CLUTCH ADJUSTMENT / 1971 & LATER SPORTSTER

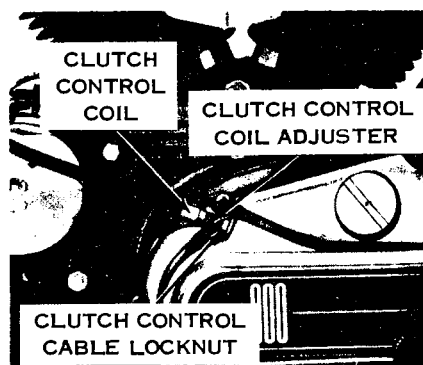
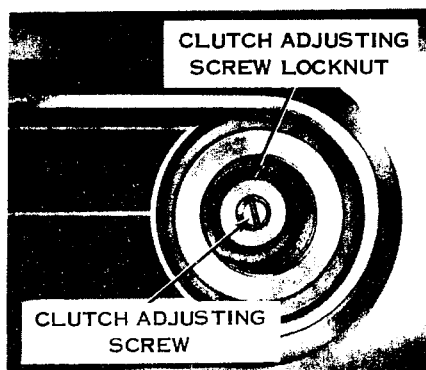
The procedure for this clutch cable adjustment as outlined in the Sportster owner and service manuals require the removal of the chain housing cover. To eliminate the need for cover removal, the following new procedure can be followed. See accompanying illustrations.

1. Remove access plug from chain compartment cover.
2. Loosen the locknut and turn the clutch adjusting screw inward until it starts to release the clutch (screw turns harder). Then turn the screw 2 turns farther in and lock the locknut.

3. Loosen the locknut on the control coil adjuster and turn the adjuster inward until slack can be felt in the cable (some play at handlever). From that point, turn the adjuster back out to a position where all slack in the cable is just eliminated (no play at handlever) and tighten the locknut. This is the correct cable adjustment.

4. The clutch release adjustment should then be made with the clutch adjusting screw as follows: Loosen the locknut and back off the adjusting screw until the clutch is engaged (screw turns easier), then turn screw inward until the point where free play has just been eliminated. From this point, turn the adjusting screw outward 1/4 turn to establish correct free play, and tighten locknut.
